SERVICE BULLETIN: 02001-2

Date 01/30/02

Models:	TX-DS797 / TX-DS898
Symptom:	Static like Noise (tic, tic,) occurs when in surround mode with a limited possibility of Surround Back not functioning.
Cause:	Power Supply VCC for Q713 may be too high.
Solution:	Reduce VCC or Replace Q713. Must Perform Bulletin 02002-2 For <u>Dolby Digital Audio Drop Out</u> as well.

SERVICE BULLETIN: 02002-3

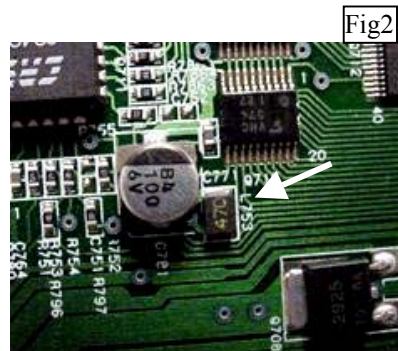
In some units Q713 IC, brand **ISSI**, IS62LV1024LL-70H was used [Fig1], where as in some NEC MPD441000LGU-B70X may be found. For those units using the **ISSI** SRAM and having the above aforementioned problem, you will need to replace the IC Q713 with PN#22241793R3 having NEC MPD441000LGU-B70X or Mitsubishi M5MV108DKV-70H brand label. If above part is to be replaced L753 need not be replaced. See Note.

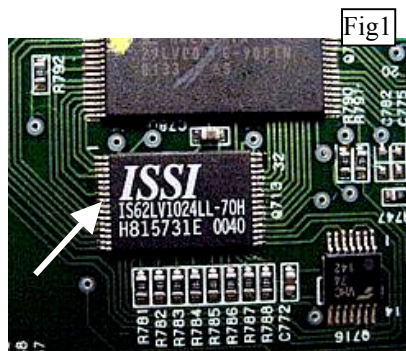
For units having not developed such problem and has the **ISSI** IC in place, it is highly recommended that L753 [Fig2] be changed to 33Ω (PN#433223304R1) chip resistors and need not replace IC.
